SUBJECT: **REVISION "C" TO ALERT SERVICE BULLETIN 206L-04-127 (TAIL ROTOR BLADES 206-016-201-131, CHECK/INSPECTION OF).**

NO. 206L-04-127

DATE	Mar 05, 2005
REV	C

SUBJECT: TAIL ROTOR BLADES 206-016-201-131,
CHECK/INSPECTION OF

Figure 1. Tail rotor blade inspection.

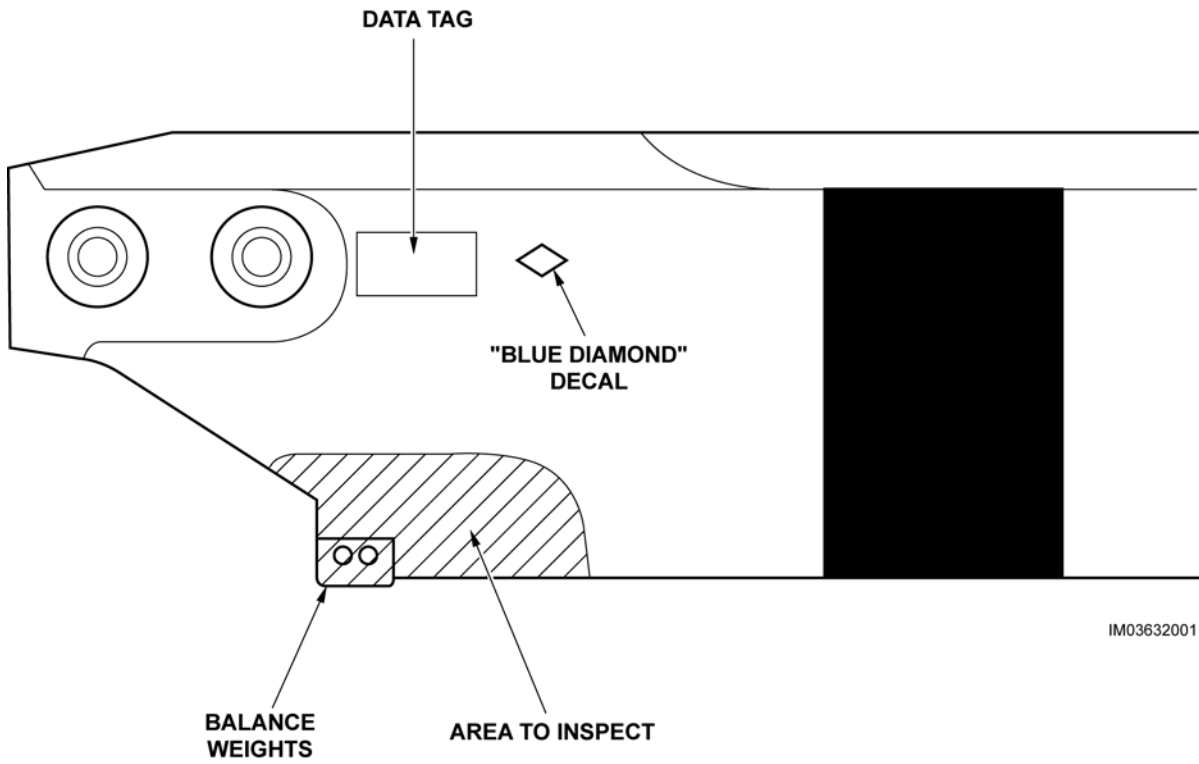
1. Use detergent (C-318) and thoroughly clean the area to be checked on both sides of the blade. Refer to Figure 1.
2. Check both sides of the blade at the area indicated on the Figure 1 as follows:
 - a. Visually check the skin for deformation or cracks.
 - b. If deformation or cracks are found, remove the blade from service.
 - c. Check the weights for bends or deformation.

1. Use detergent (C-318) and thoroughly clean the area to be inspected on both sides of the blade. Refer to Figure 1.
2. Inspect both sides of the blade at the area indicated on the Figure 1 as follows:
 - a. Visually inspect the skin for deformation.
 - b. With a 10 X power magnifying glass inspect the skin for cracks.
 - c. If skin deformation or cracks are found remove the blade from service.
 - d. Inspect the weights for bends or deformation.
 - e. If the weights are bent or deformed, remove the blade from service.
3. If no damage is found, the blade is serviceable.
4. Make log book entries to show that the PART I b. of this Alert Service Bulletin has been accomplished.

1. Use detergent (C-318) and thoroughly clean the area to be inspected on both sides of the blade. Refer to Figure 1.
2. Inspect both sides of the blade at the area indicated on the Figure 1 as follows:
 - a. Visually inspect the skin for deformation.
 - b. With a 10 X power magnifying glass inspect the skin for cracks.

- c. If skin deformation or cracks are found remove the blade from service.
 - d. Inspect the weights for bends or deformation.
 - e. If the weights are bent or deformed, remove the blade from service.
3. If no damage is found, the blade is serviceable.
 4. In order to provide a quick visual reference and identify the blades affected by this ASB, apply the "blue diamond" decal provided with this ASB on both sides of the blade at the location indicated on the Figure 1. To prolong the life of the decal, apply Edge sealer on the decal. Replace missing or damaged decal as required.
 5. Make log book entries to show that the PART II of this Alert Service Bulletin has been accomplished. Clearly indicate also that the PART I a. or I b. of this Alert Service Bulletin has to be performed every 3 or 12 flight hours as directed by the compliance section.
